河源市信强峰科技有限公司		
DWG.: Nick 15-Nov-2017	Title	UHF
CHK: CHK	Model No.:	SK-12V6
APP: APP	Drawing No.:	SCH_SK-12V6-01V05
	Rev.:	04
	Sheet	1 of 1
	Size:	A3
		ENG-015-B

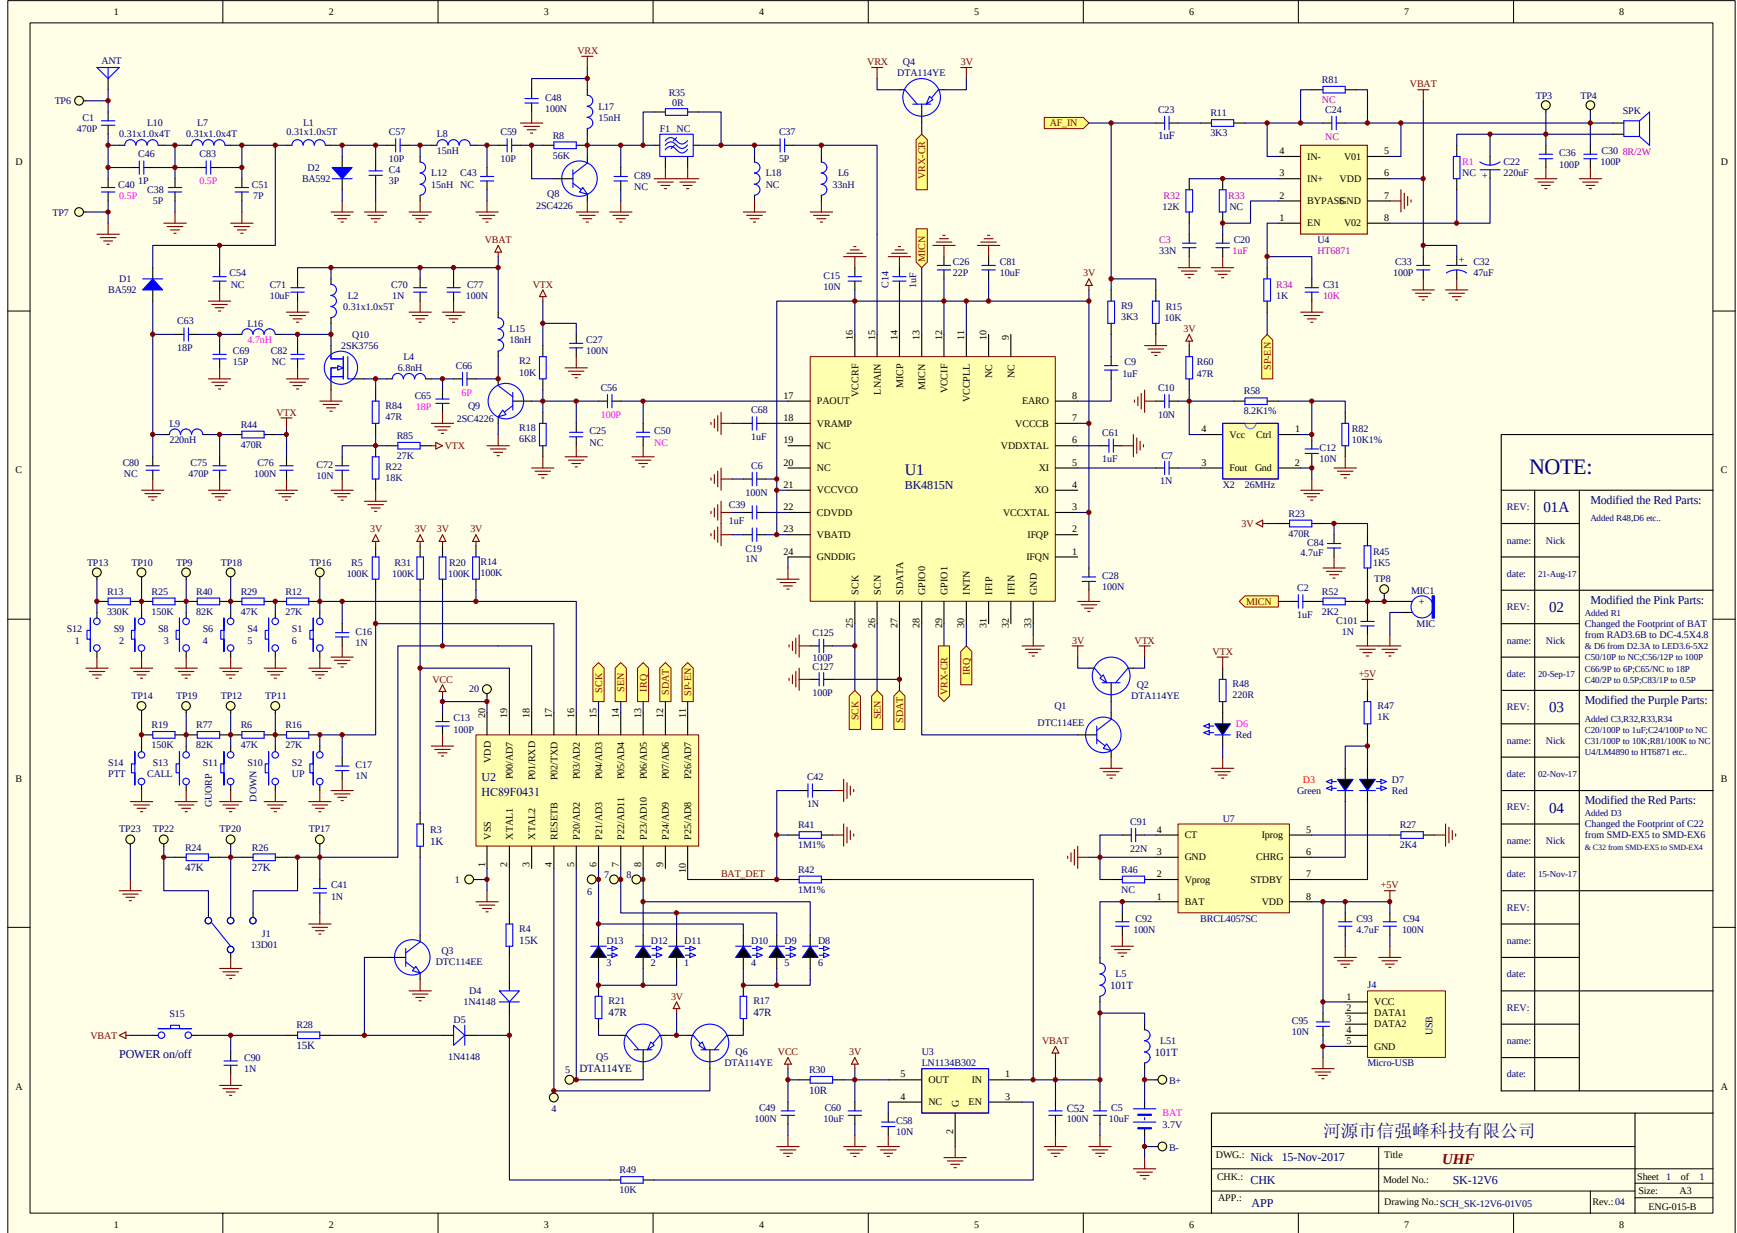
REV:	01A	Modified the Red Parts:
name:	Nick	Added R40,D6 etc...
date:	21-Aug-17	
REV:	02	Modified the Pink Parts:
name:	Nick	Added R1 Changed the Footprint of BAT from RAD3.6B to DG-4.5X4.8 & D6 from DZ.3A to LED3.6-5X2 C2010P to NC,C505.12P to 100P C669P to 6P,C657NC to 18P C402P to 0.5P,C331P to 0.5P
date:	20-Sep-17	
REV:	03	Modified the Purple Parts:
name:	Nick	Added C3,R32,R33,R34 C20/100P to 1uF,C24/100P to NC; C31/100P to 10K,R81/100K to NC; U4/LM4850 to HT6871 etc.
date:	02-Nov-17	
REV:	04	Modified the Red Parts:
name:	Nick	Added D3 Changed the Footprint of C22 from SMD-EX5 to SMD-EX3 & C32 from SMD-EX5 to SMD-EX4
date:	15-Nov-17	
REV:		
name:		
date:		
REV:		
name:		
date:
